FIRE SAFETY INSPECTION REPORT

SHAFI KNIT LTD

ACCORD ID: 23395

Date: 12 May, 2019

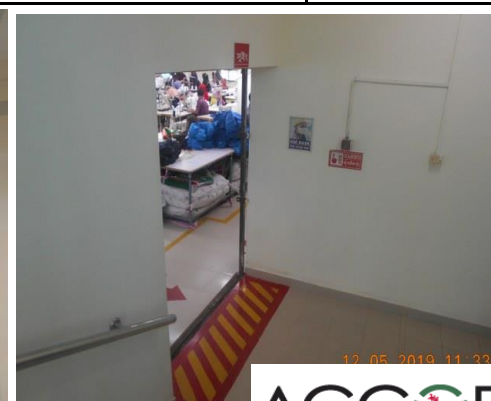
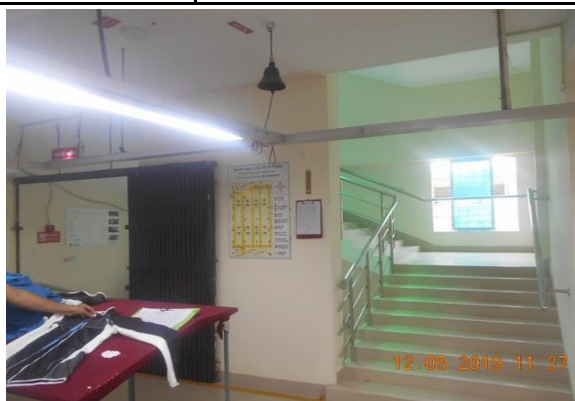
3	Fire Rated Construction	<p>Areas used for combustible storage open to the factory are not separated by fire rated construction.</p> <p>Location: 1st floor</p>	<p>Separate the dedicated storage rooms by minimum 1-hr fire-rated construction. Provide 0.75 hr. fire rated door and seal all penetrations and openings by 1 hr. fire rated fire rated barrier construction.</p> <p>Where separate storage rooms are not feasible, provide defined storage areas and limit the storage arrangement as follows: - Maximum height of 2.45m (8ft.) and maximum area of 23m² (250 ft²) - If sprinkler protected: maximum height of 3.66m (12ft.) and maximum area of 93m² (305ft²). Separate areas of unenclosed combustible storage by a minimum clear distance of 3m (10ft.).</p>	Within 3 months
